ACCESSION NBR: 8604290033 DDC DATE: 86/04/24 NOTARIZED: NO DOCKET #  
 FACIL: 50-261 H. B. Robinson Plant, Unit 2, Carolina Power & Light C 05000261  
 AUTH. NAME AUTHOR AFFILIATION  
 CUTTER, A. B. Carolina Power & Light Co.  
 RECIP. NAME RECIPIENT AFFILIATION  
 RUBENSTEIN, L. S. PWR Project Directorate 2

SUBJECT: Requests approval to utilize damping curve developed by Pressure Vessel Research Council in ASME Code Case N-411 for piping stress analyses damping values. Changes will be incorporated into next FSAR amend. Fee paid.

H. B. ROBINSON STEAM ELECTRIC PLANT, UNIT NO. 2  
DOCKET NO. 50-261/LICENSE NO. DPR-23  
PIPING STRESS ANALYSES DAMPING VALUES

Figure 3.7.2-7

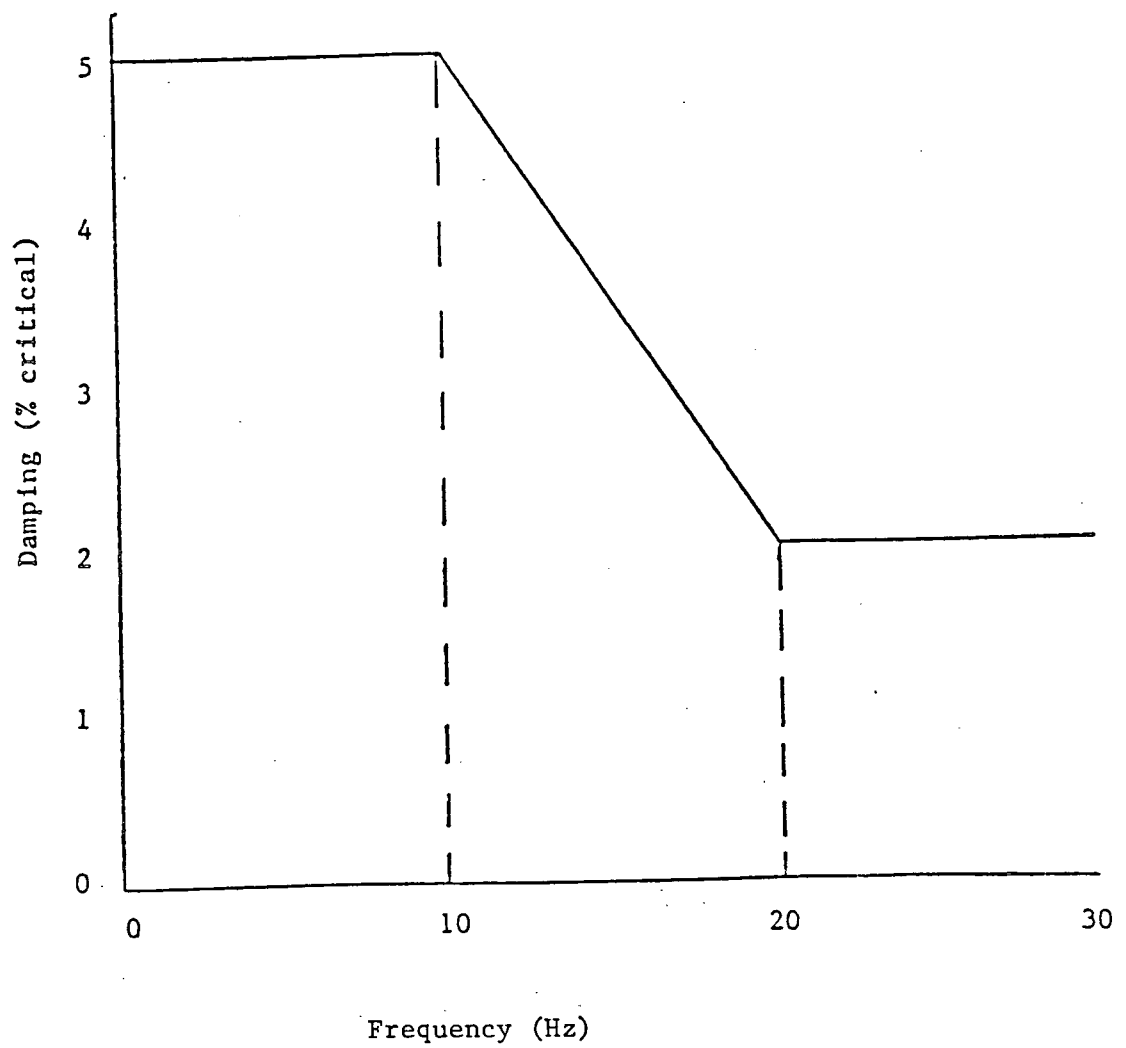
The optional damping values for piping in Table 3.7.2-1 and Figure 3.7.2-7 may be used if the criteria in 3.7.3.2.7.3 is followed.

The damping values given in Figure 3.7.2-7 may be used as an option to the preceding methods only if the following analysis criteria are followed:

- a)      A response spectrum analysis is performed and not a time-history analysis.
- b)      The rigid frequency cutoff used is 33 Hz.
- c)      Closely spaced modes are evaluated per RG 1.92.
- d)      A 3-D SRSS modal combination is used.
- e)      For piping system backfit analysis, any increased deflection due to removal or modification of supports shall be evaluated.
- f)      The alternate damping values shall not be mixed with the RG 1.61 criteria in the same analysis.

\* For final reconciliation of pipe stress analysis or piping system backfits, damping values as defined in ASME Code Case N-411 (Figure 3.7.2-7) may be utilized for both OBE and DBE.
